TOWN HOMES AT

2855 PIERCE STREET HOLLYWOOD FL 33020

FILE NUMBER:20-DP-49

SUBJECT: Final TAC review for a 13-unit residential development
(Pierce Street Affordable Townhomes)

[GET TITLE](#)
[NOTES](#)
[SIGNAGE NOTES](#)
[GREEN BUILDING NOTES](#)

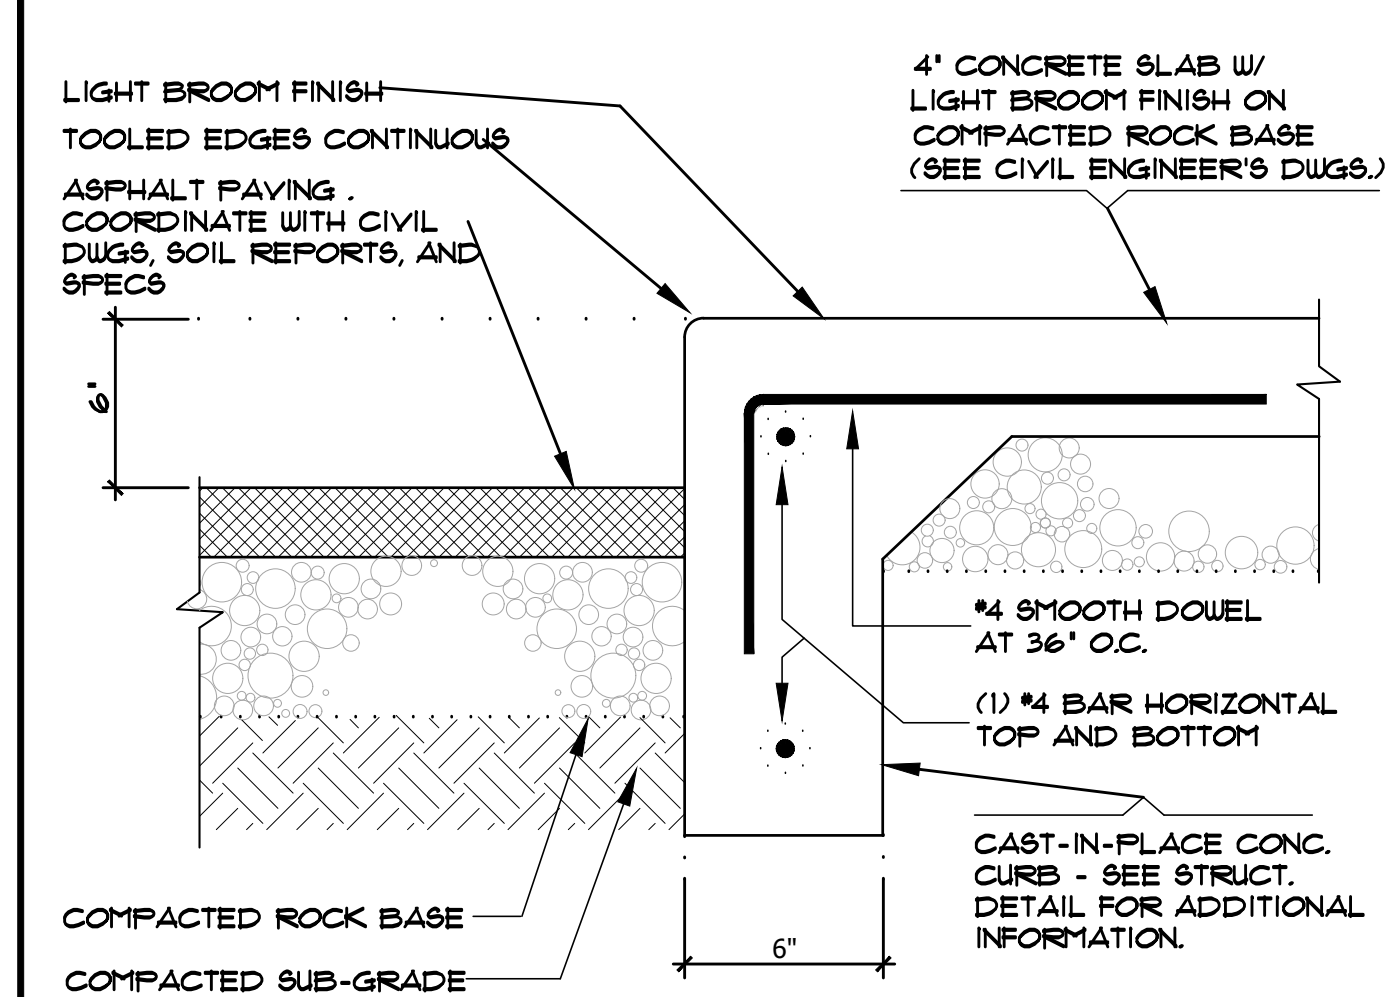
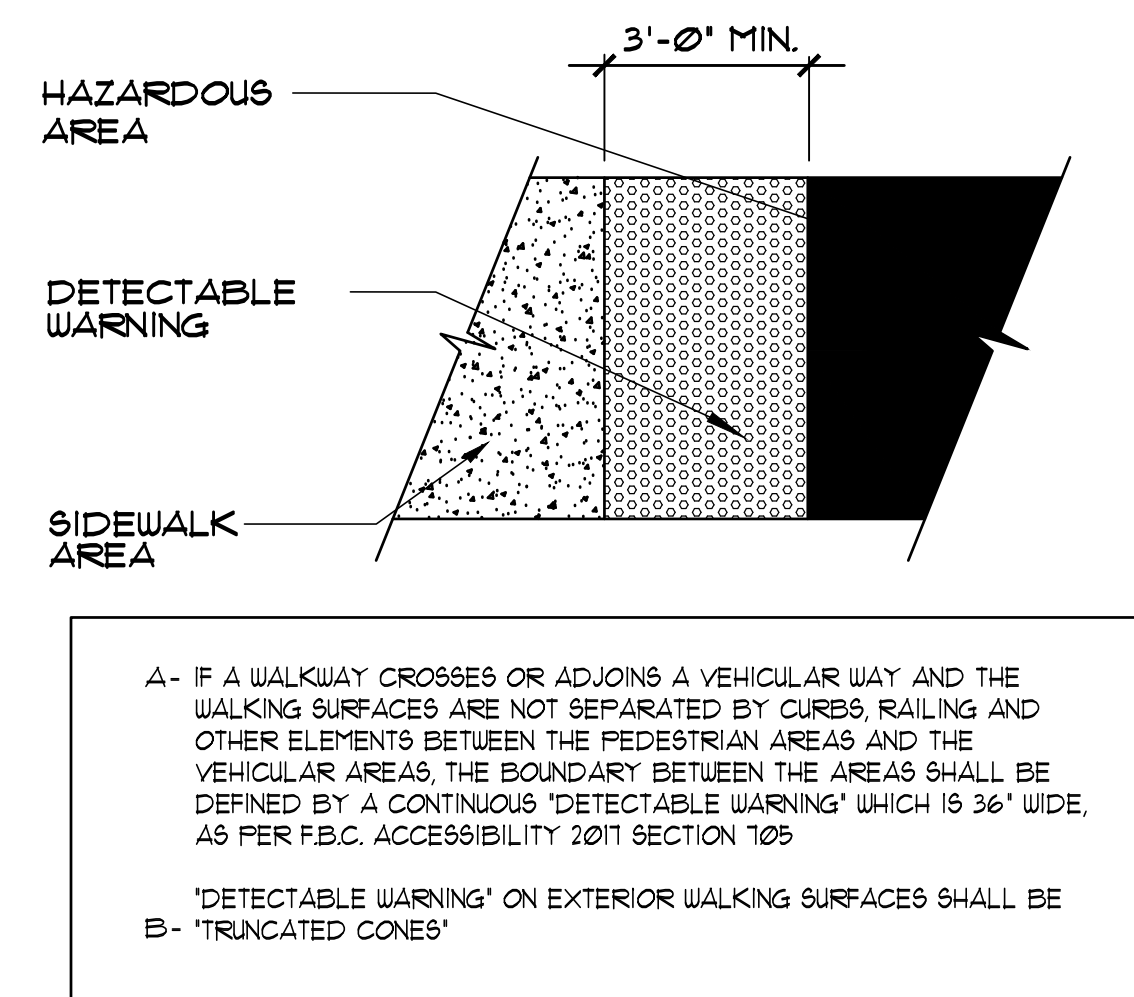
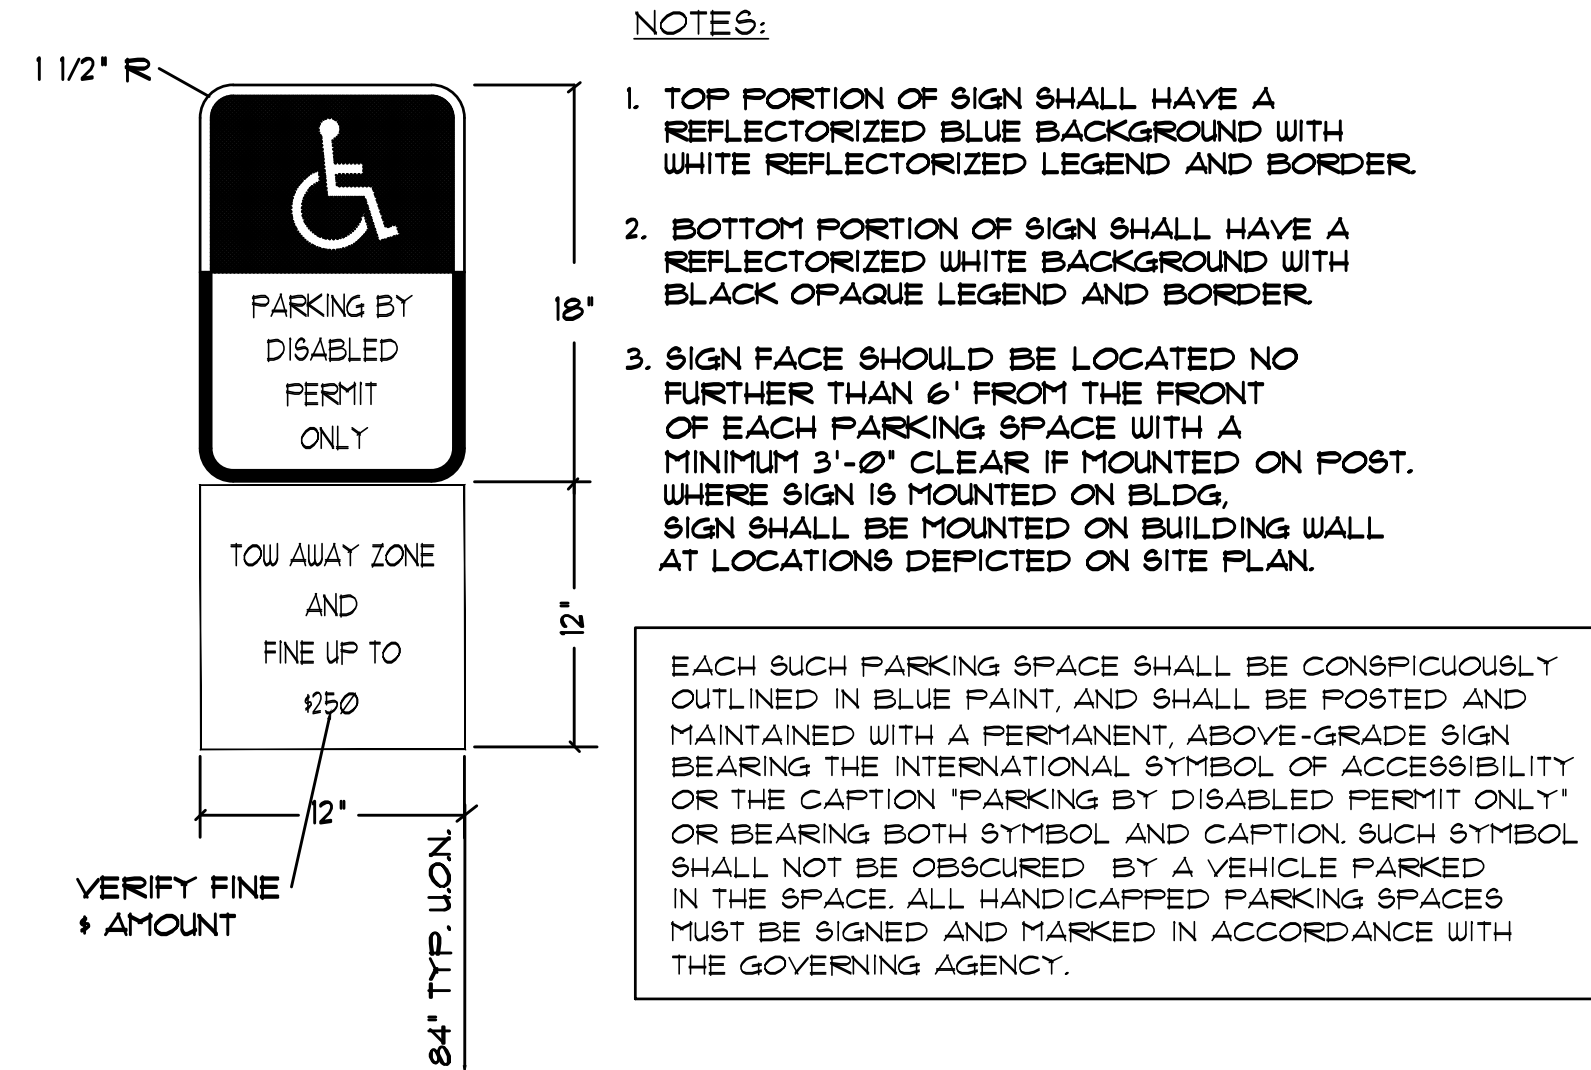
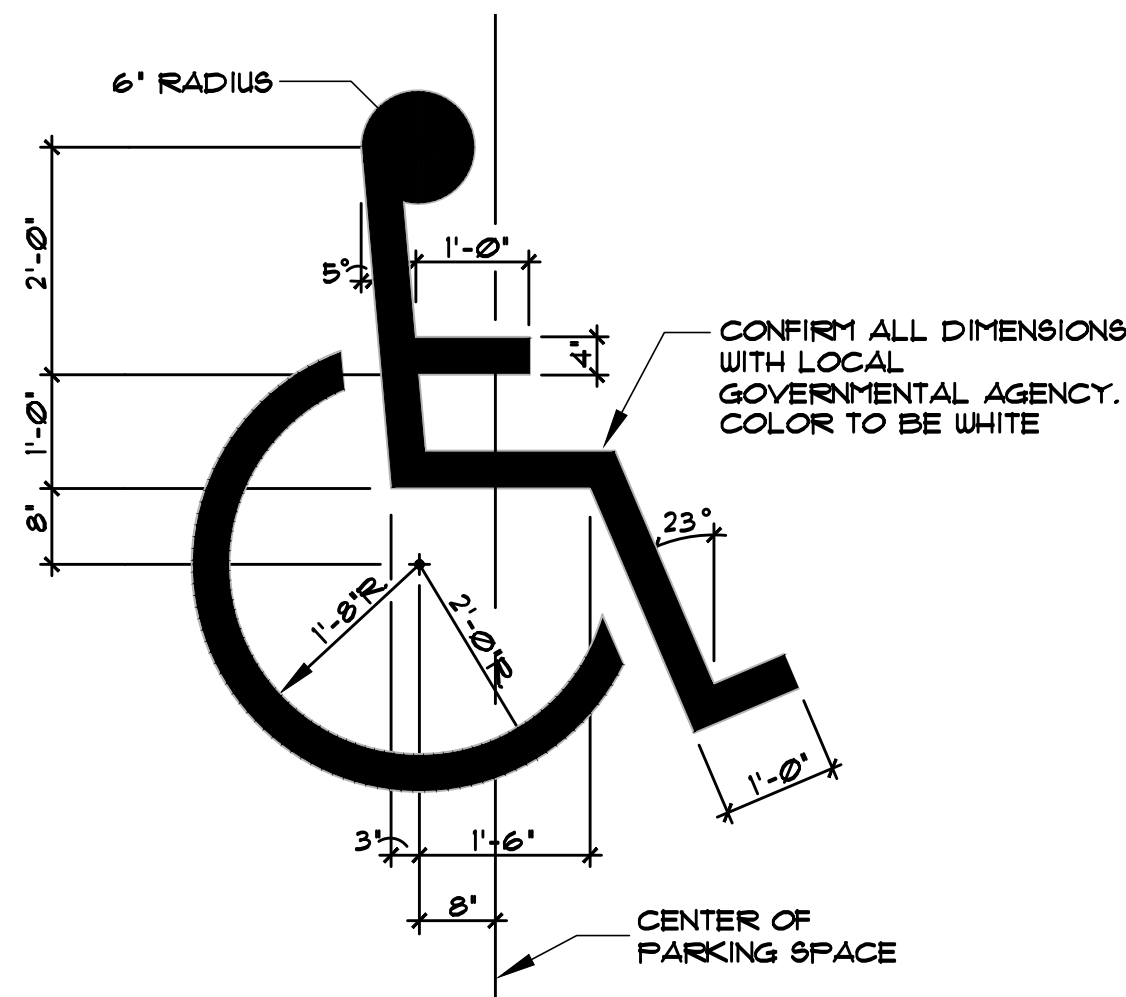
1. Include note on Site Plan, all signage shall be in compliance with the Zoning and Land Development Regulations.

This is noted on sheet SP-0 where signs for the building is noted.

PROPOSED FIRST FLOOR PLAN

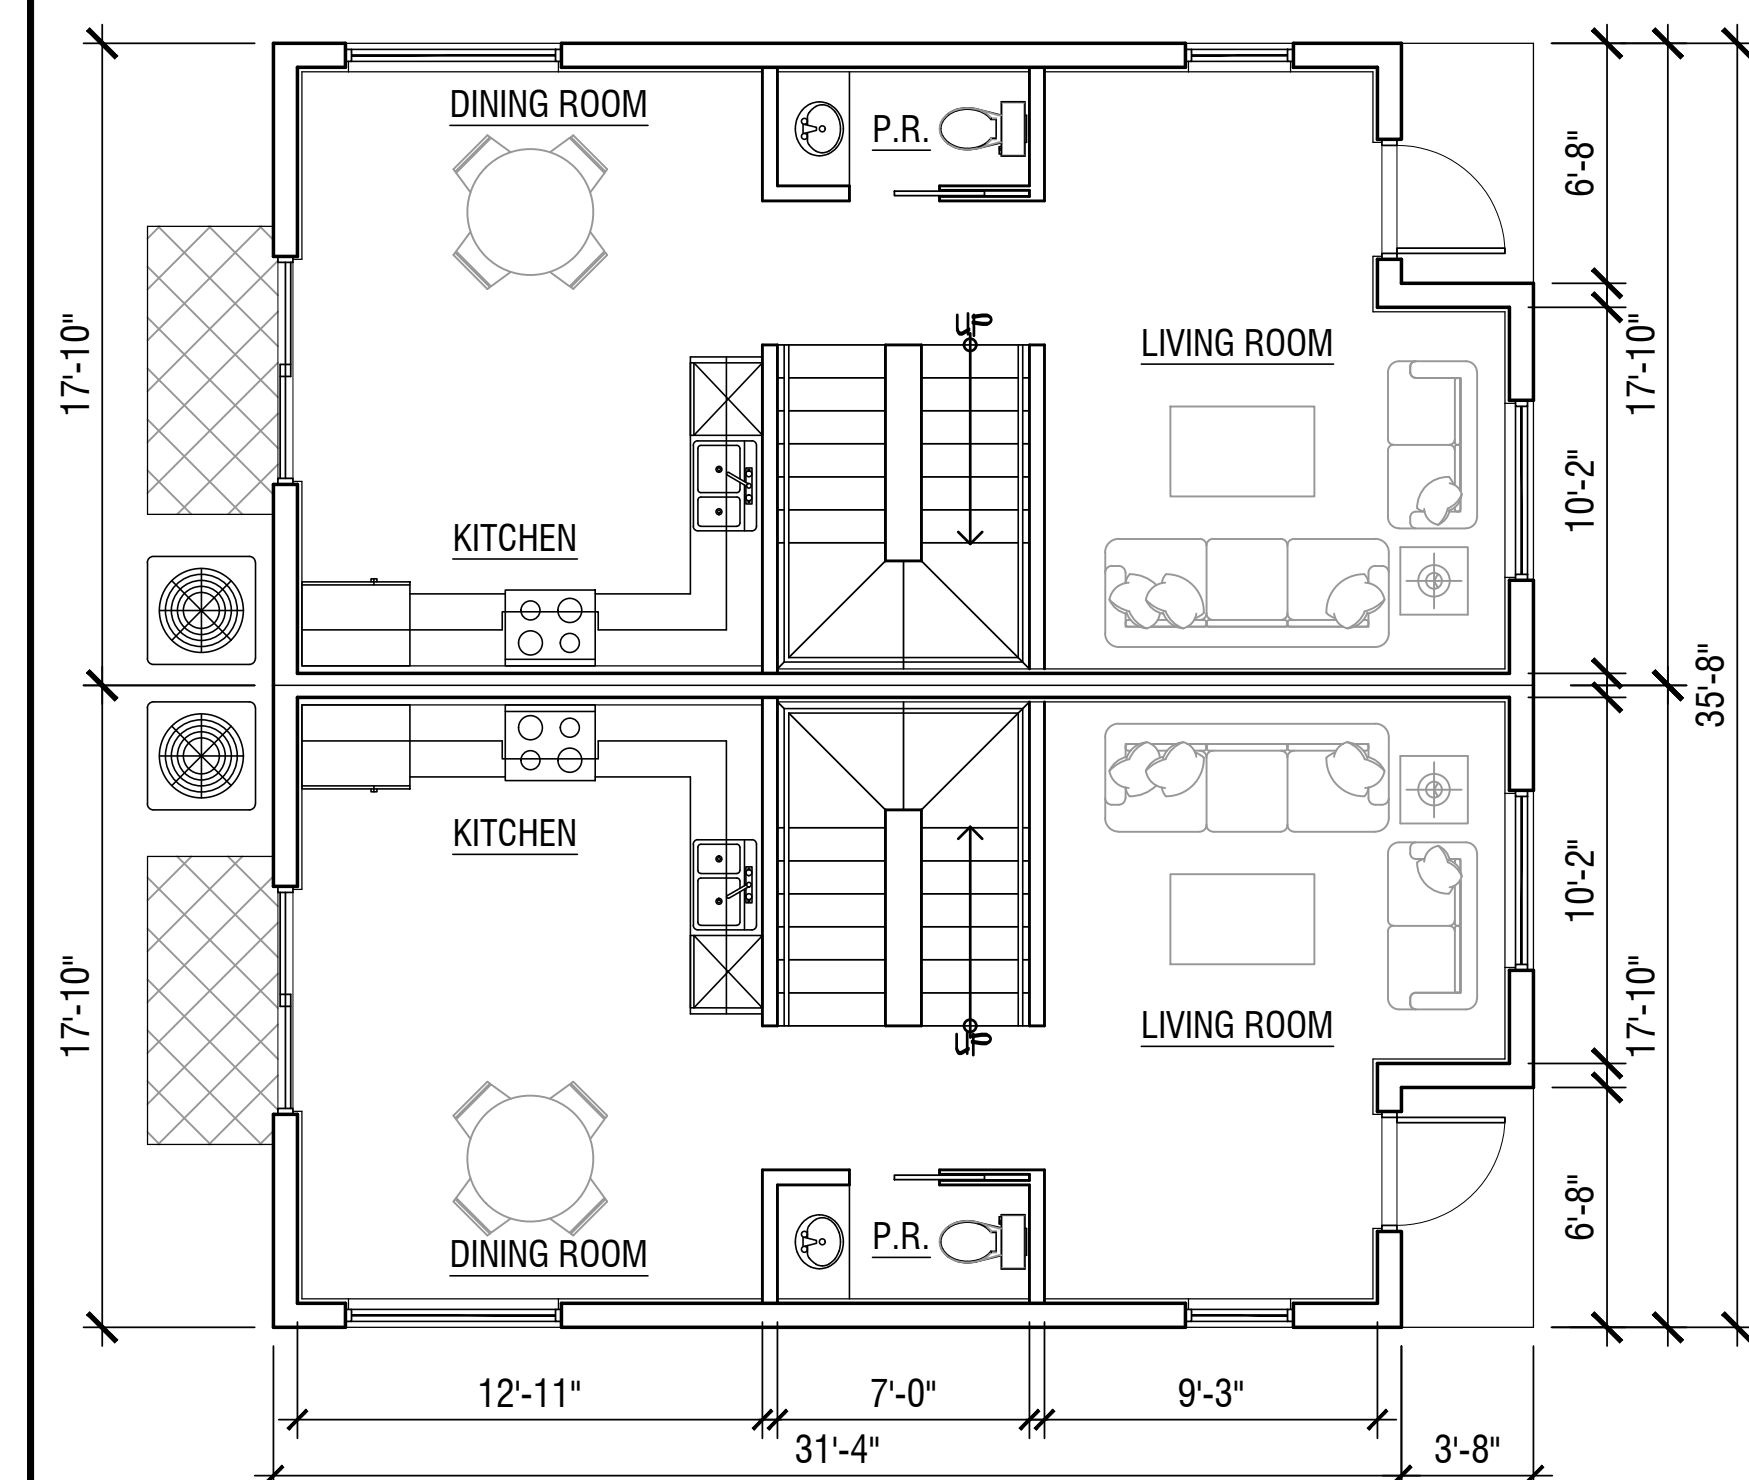
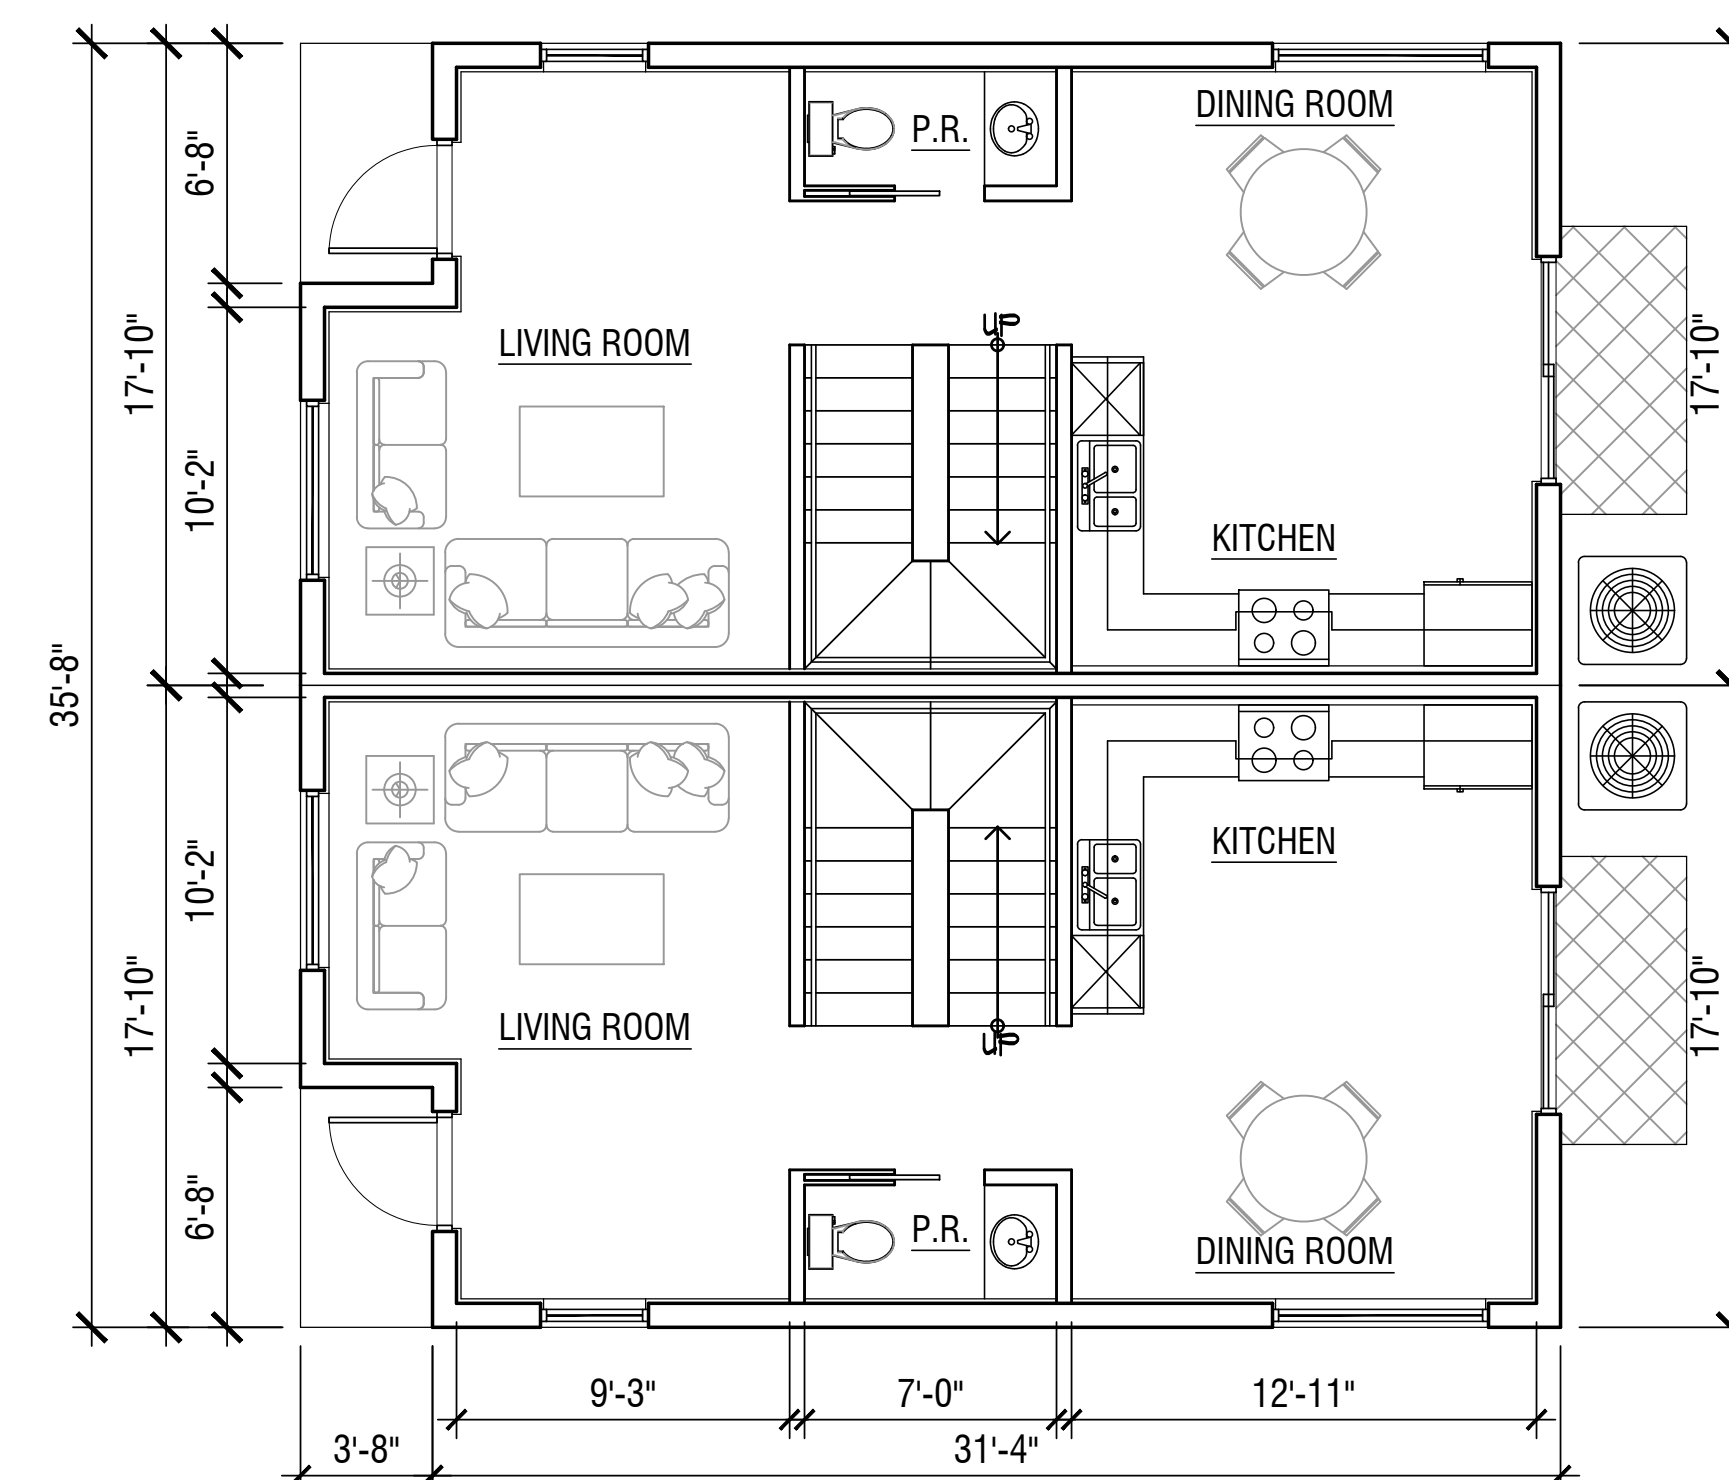
- f. Provide the square footage per floor air-conditioned and non-air-conditioned areas separately.
This is noted on the sheets (A-1, A-2 and A-3) as requested.
